Subject: Class 1 Permit Modification Notification, Waste Isolation Pilot Plant Hazardous Waste Facility Permit Number: NM4890139088-TSDF

- Completion of Panel 8 Mining

Class 1 Permit Modification Notification

Completion of Panel 8 Mining

Figure A4-4a
Typical Underground Transport Route Using W-30

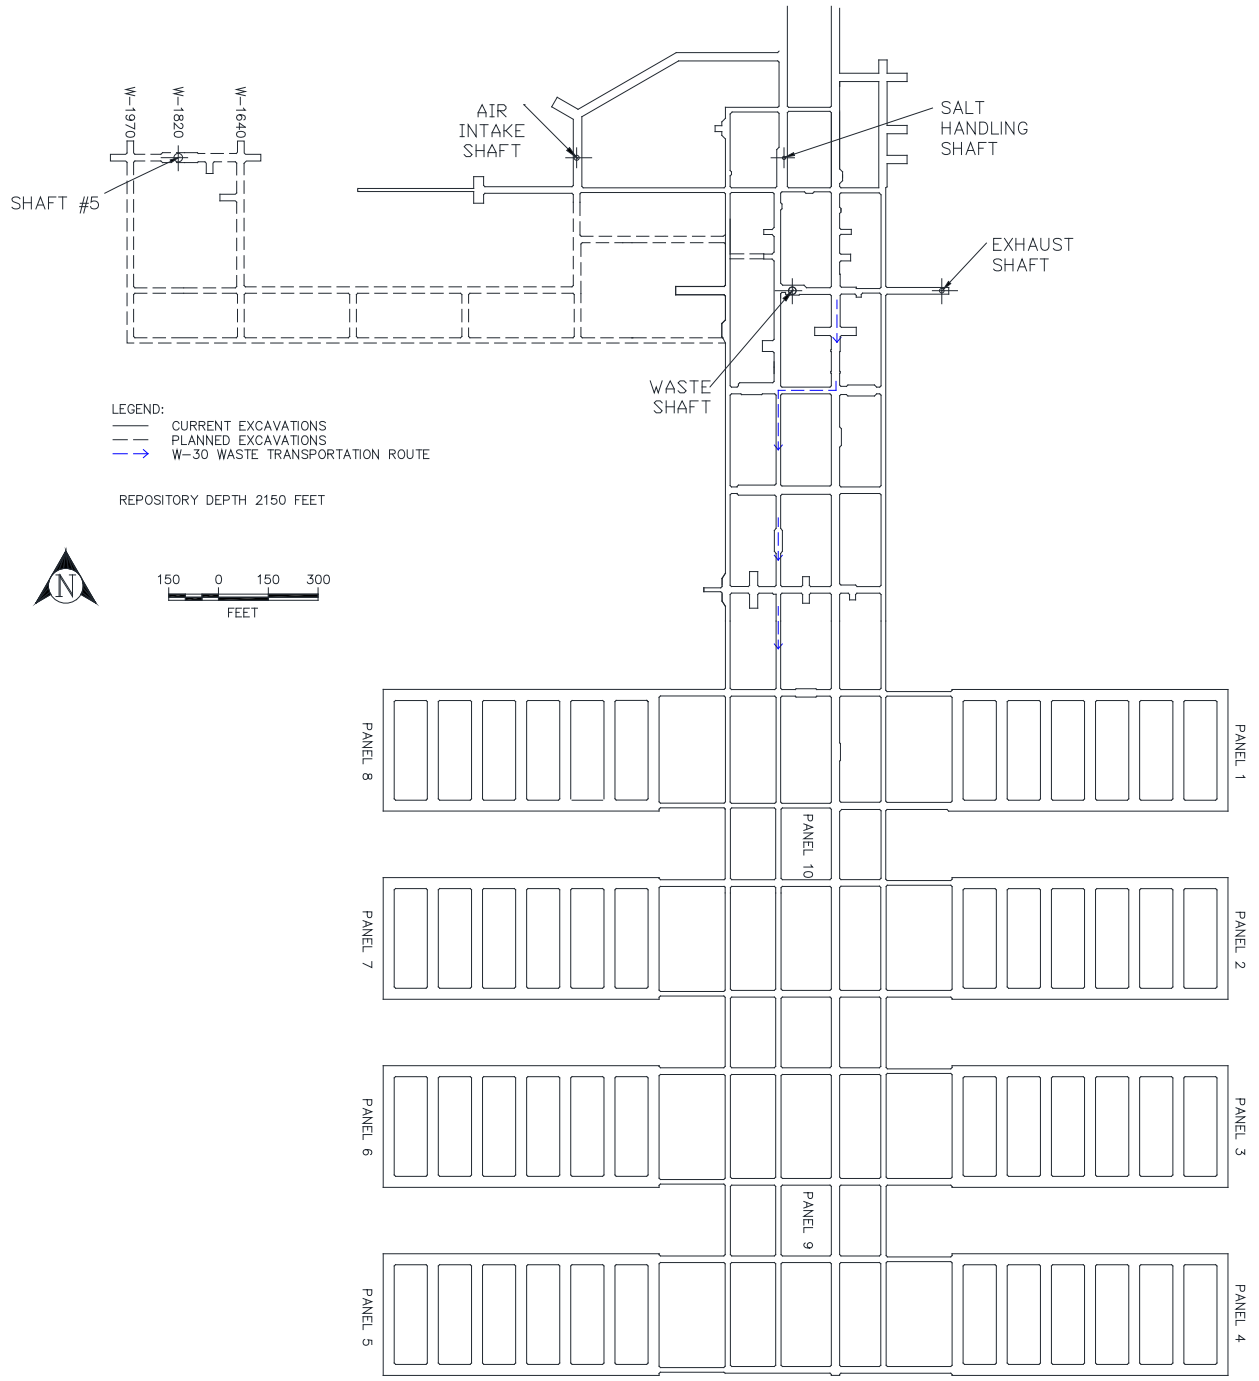
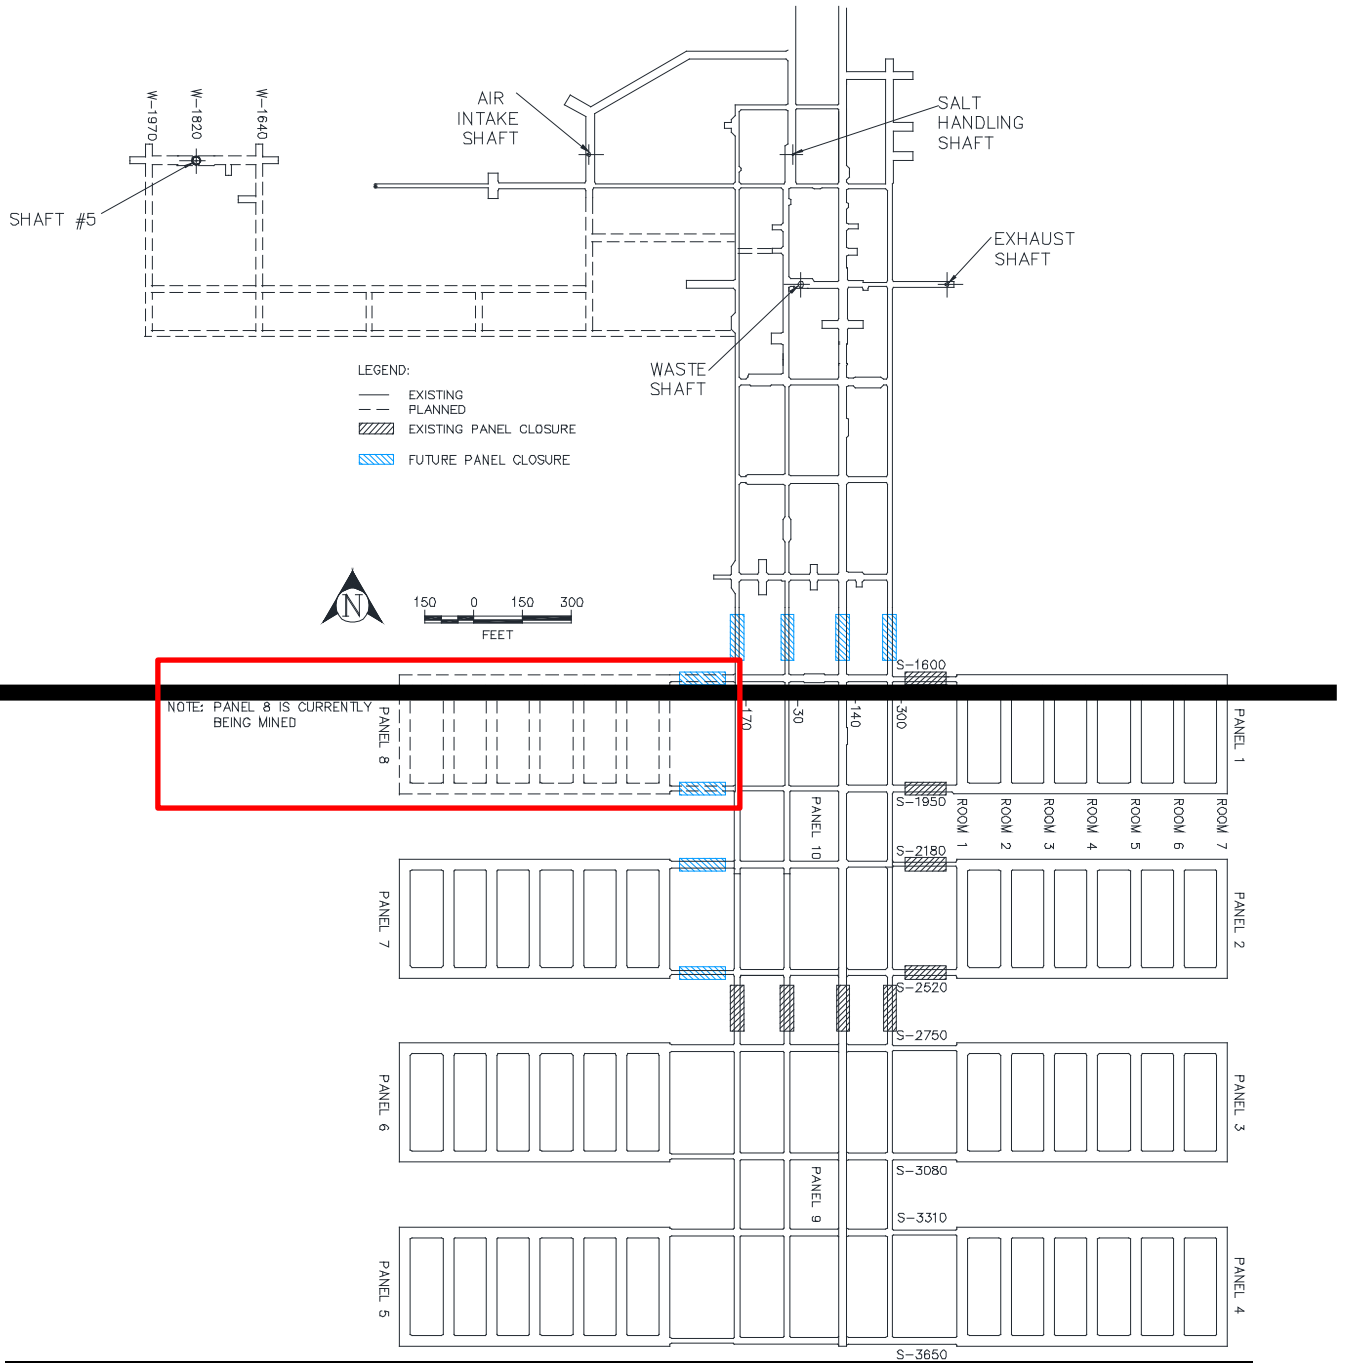
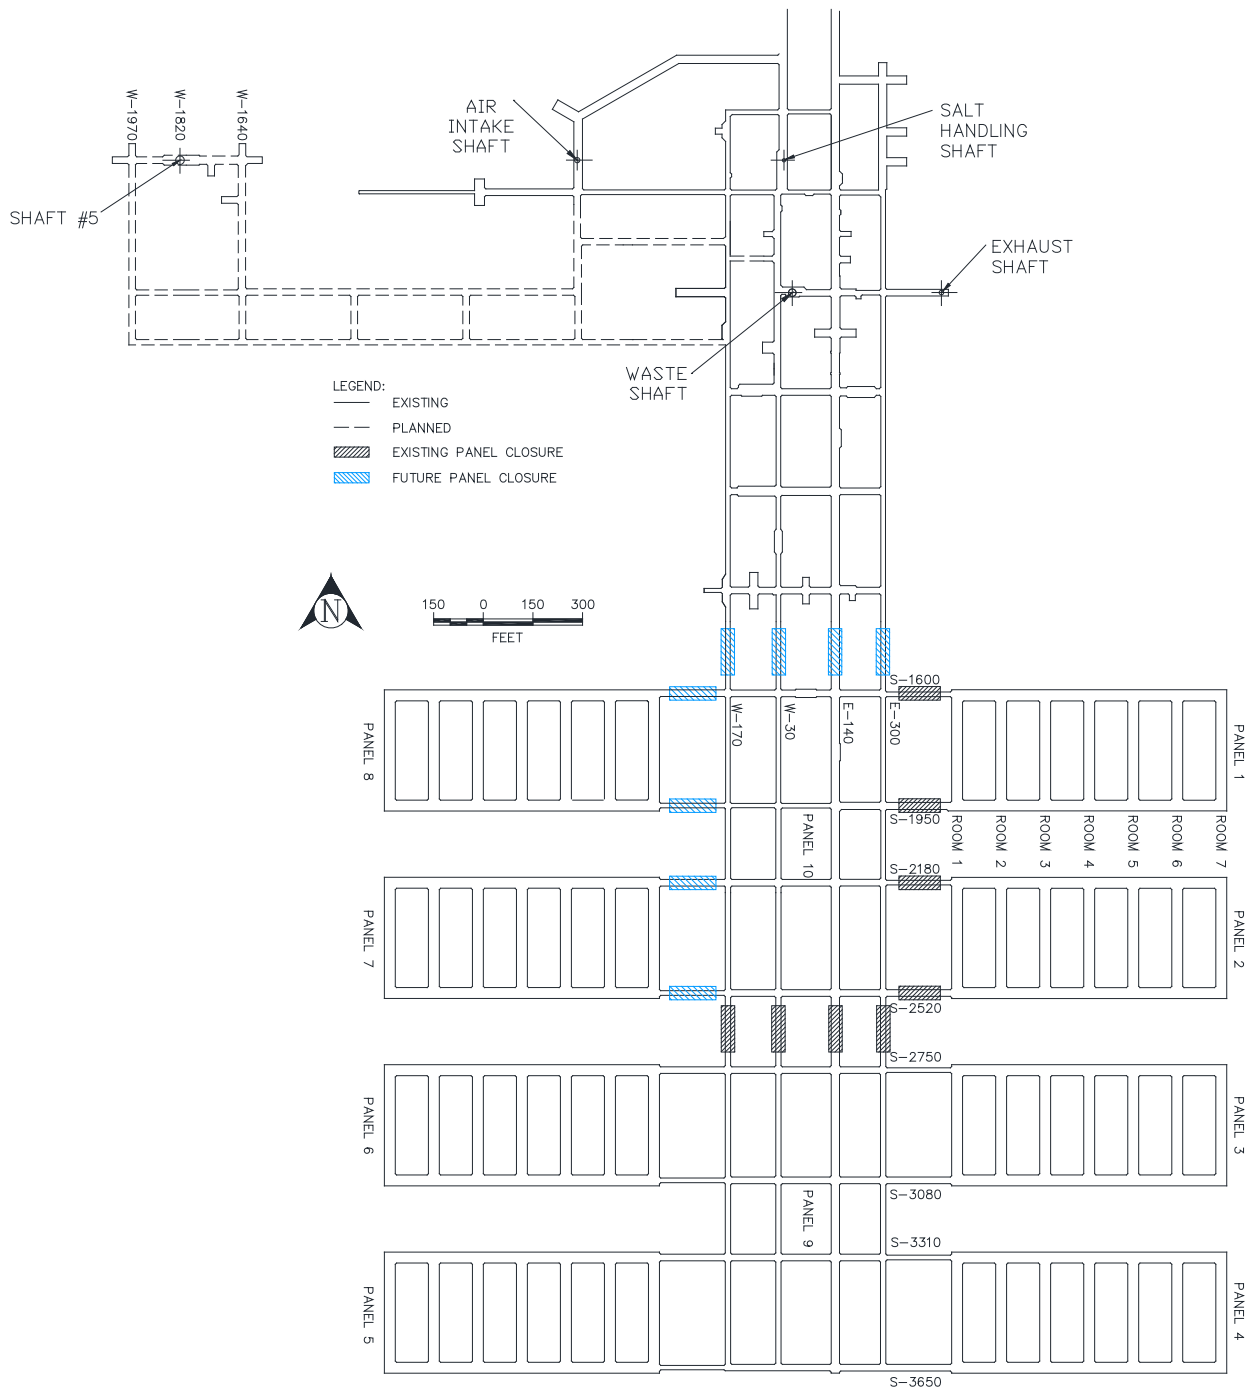
- Permit Attachment A4, Figure A4-4a, *Typical Underground Transport Route Using W-30*
 - Changed Panel 8 dashed lines into solid lines.
 - Changed the planned excavations lines from blue to black.

- Changed the waste transportation route to reflect the route for waste emplacement in Panel 8.
 - Deleted the following figure text: “NOTE: PANEL 8 IS CURRENTLY BEING MINED” because Panel 8 status has changed from planned to existing.

**Figure B3-2
Repository Horizon**

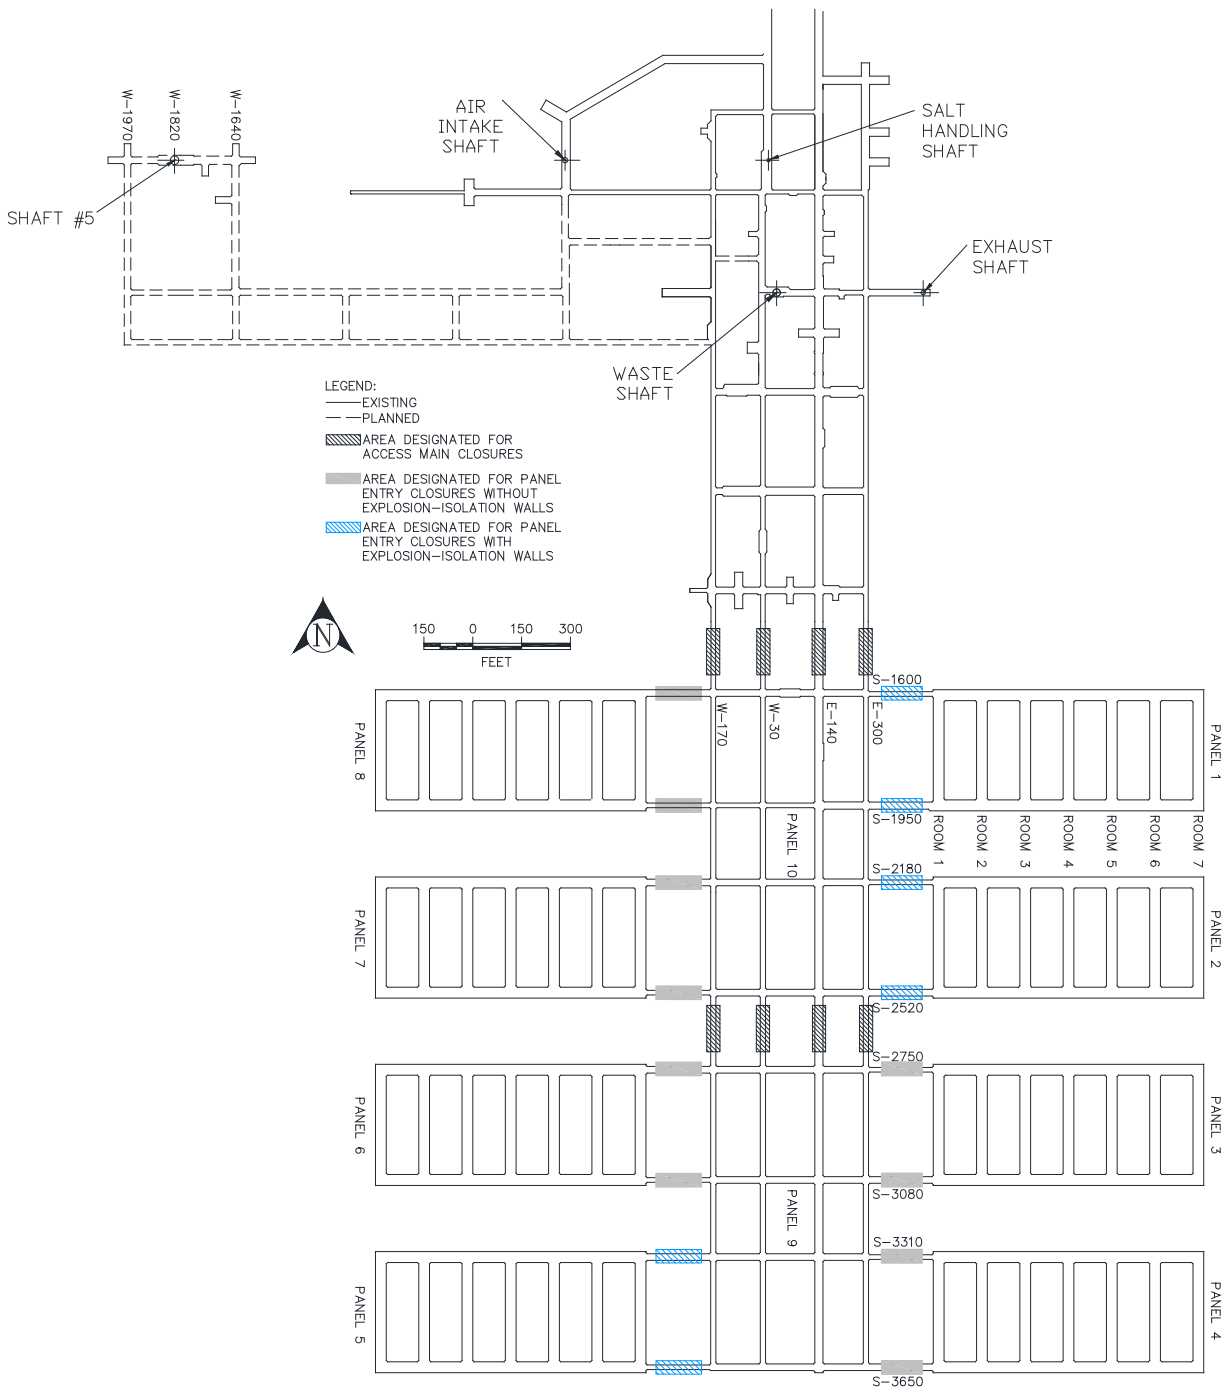
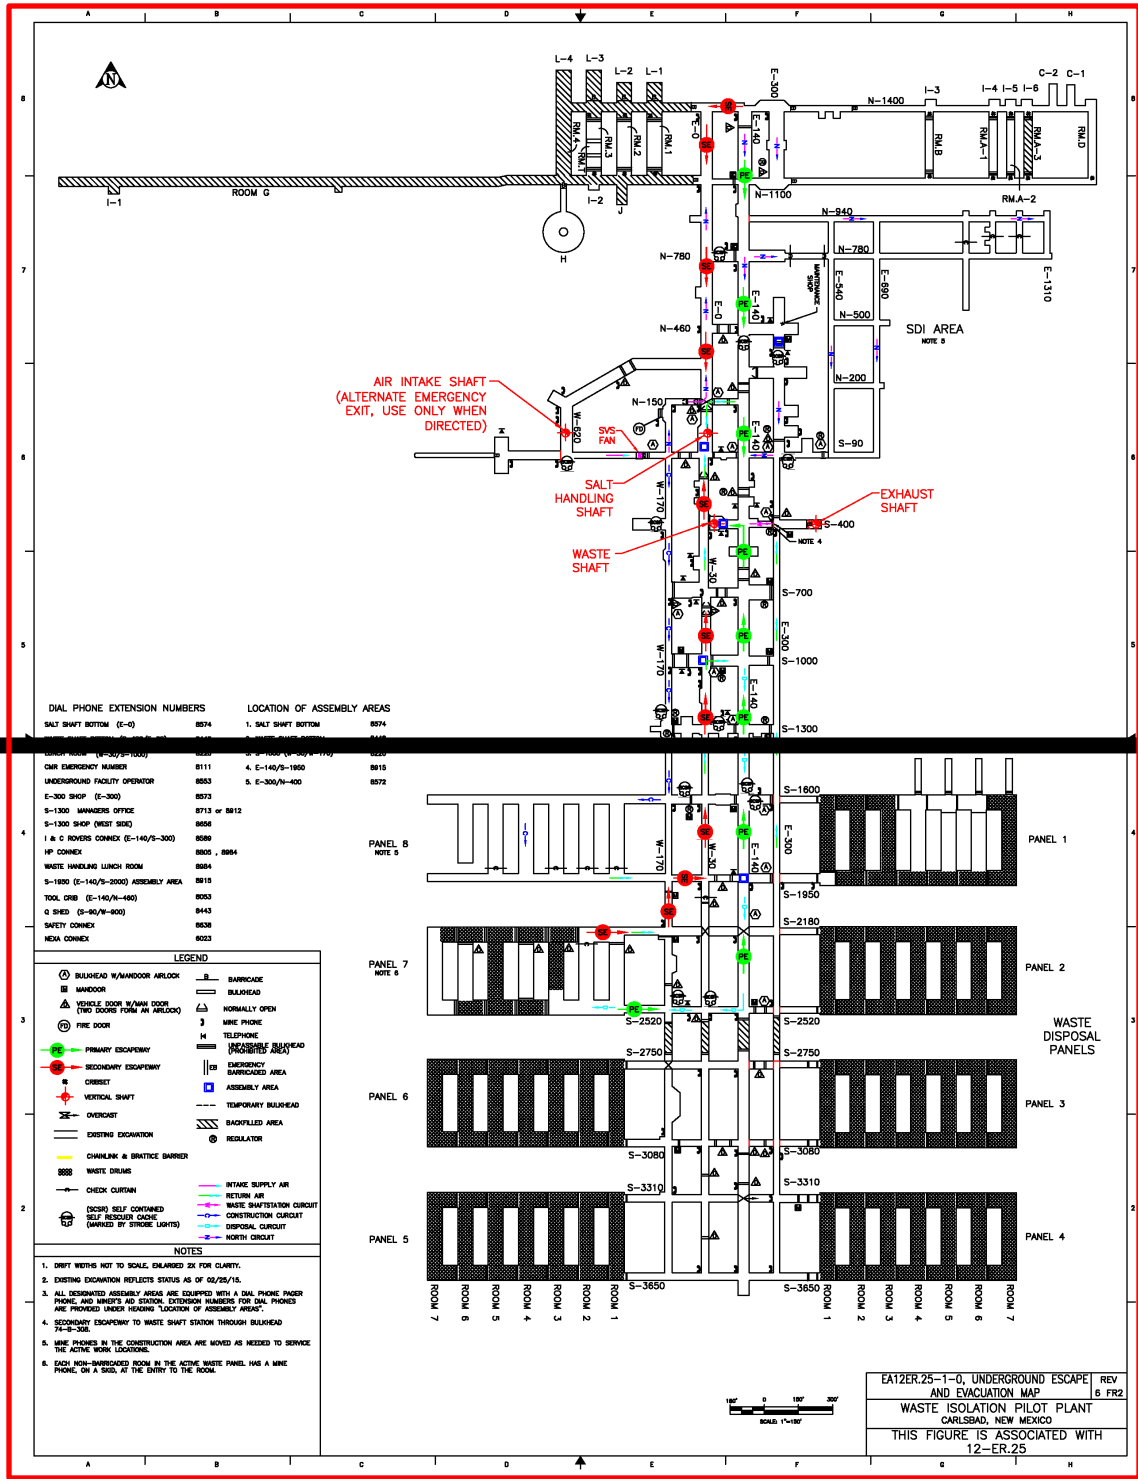
- Permit Attachment B, Figure B3-2, *Repository Horizon*
 - Changed Panel 8 dashed lines into solid lines.
 - Deleted the following figure text: “NOTE: PANEL 8 IS CURRENTLY BEING MINED” because Panel 8 status has changed from planned to existing.
